# 1966 Corvette: Service Bulletin: Automatic Choke Malfunction

**Subject:** Automatic Choke Malfunction

**Bulletin No:** TSB #66-6, DR #66-6

**Date:** November 18, 1965

FIG. I - CHOKE THERMOSTAT ASSEMBLY - 283 V-8

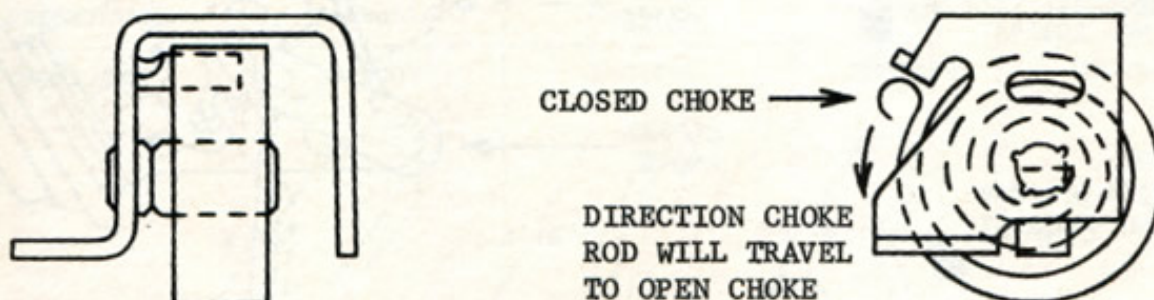
NOTE: Choke thermostat assemblies, although similar in appearance, are not interchangeable. Check bracket design as shown in Figures I, II and III and the coil spring identification number shown on chart (Number stamped in coil, not number in ink). Choke coil springs are indexed to bracket and must not be interchanged or repositioned.

FIG. IV - ROCHESTER 4MV (QUADRA JET) VACUUM BREAK ASSEMBLY

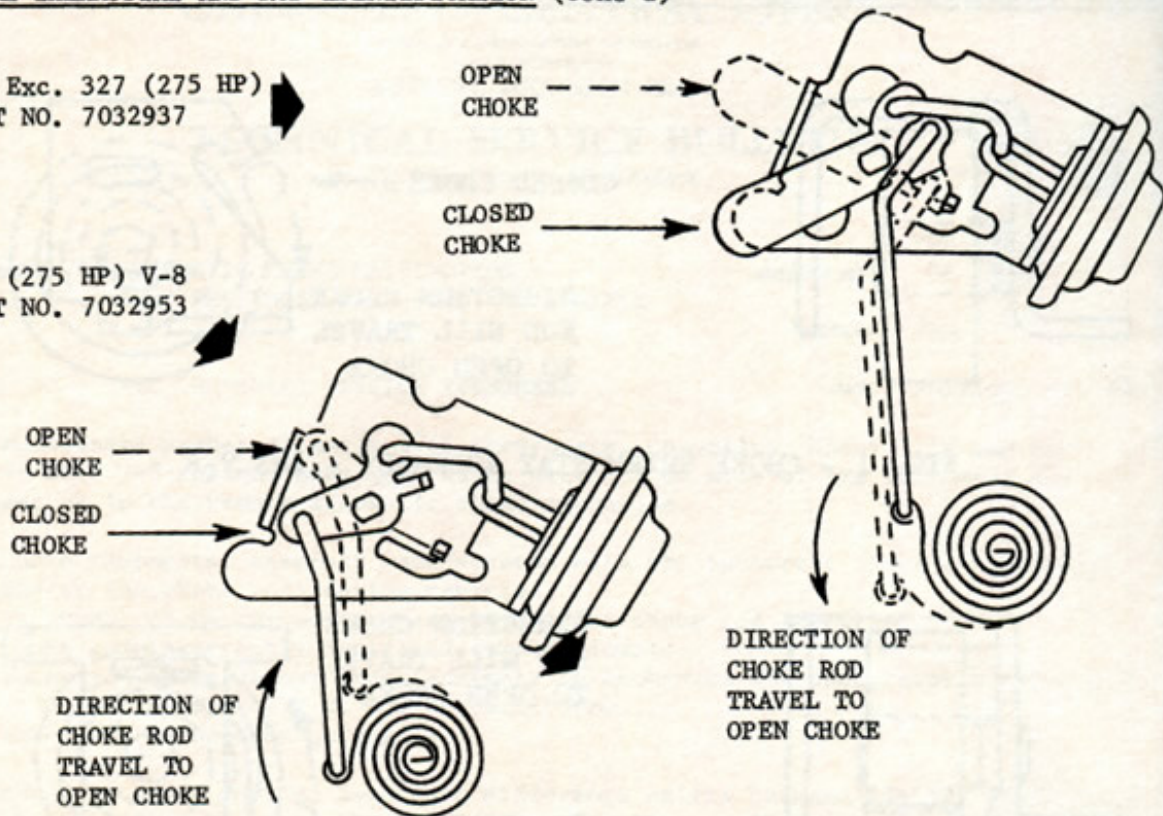
V-8 Exc. 327 (275 HP)  
PART NO. 7032937

327 (275 HP) V-8  
PART NO. 7032953

1. Remove carburetor air horn as outlined on Page 6M-25 of the 1966 Chassis Overhaul Manual.
2. Remove retaining screw from choke vacuum break assembly, then remove assembly.
3. Remove choke lever from float bowl well.
4. Install choke vacuum break assembly as outlined on Page 6M-27, Steps 5, 6, and 7 of the 1966 Chassis Overhaul Manual.
5. Install carburetor air horn as outlined on Page 6M-29 of the 1966 Chassis Overhaul Manual.

FIG. V - HOLLEY CHOKE LEVER AND VACUUM BREAK ASSEMBLY

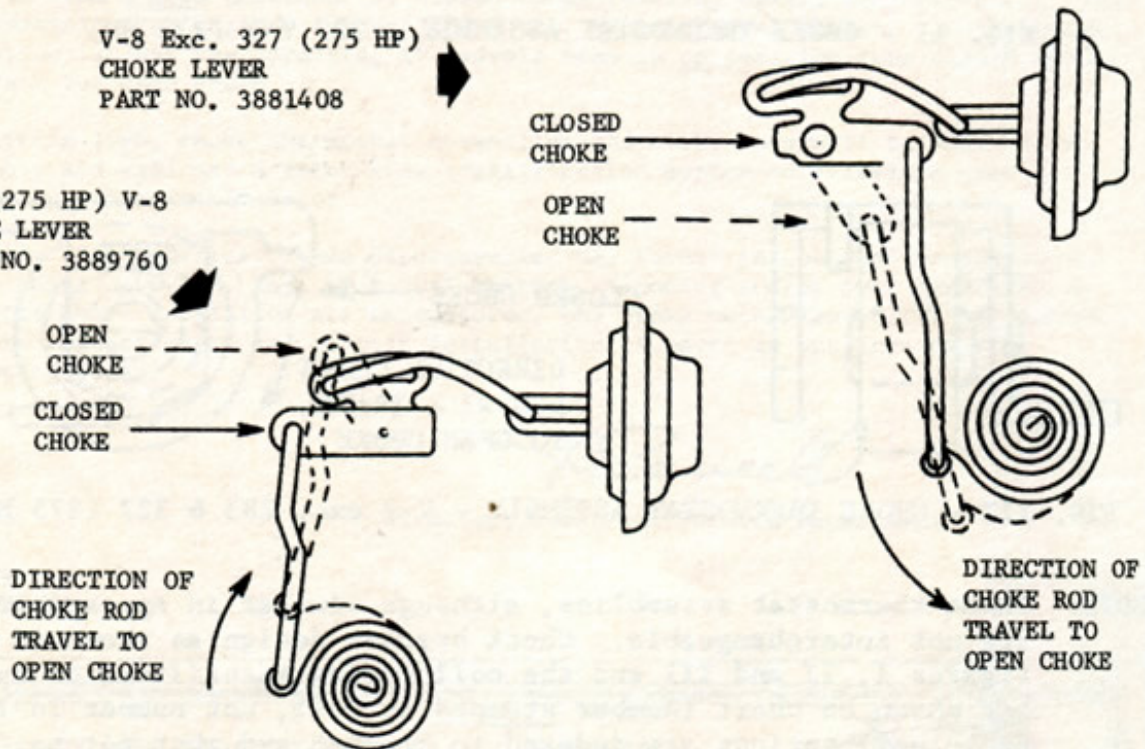
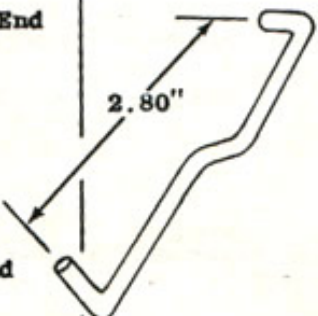
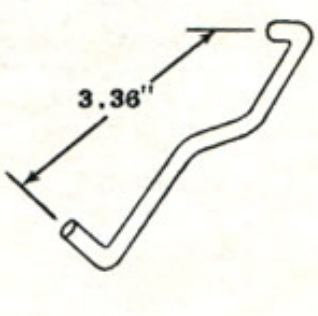
V-8 Exc. 327 (275 HP)  
CHOKE LEVER  
PART NO. 3881408

327 (275 HP) V-8  
CHOKE LEVER  
PART NO. 3889760

Disconnect choke vacuum break link, then remove choke lever retainer and choke lever. Reverse procedure to replace.
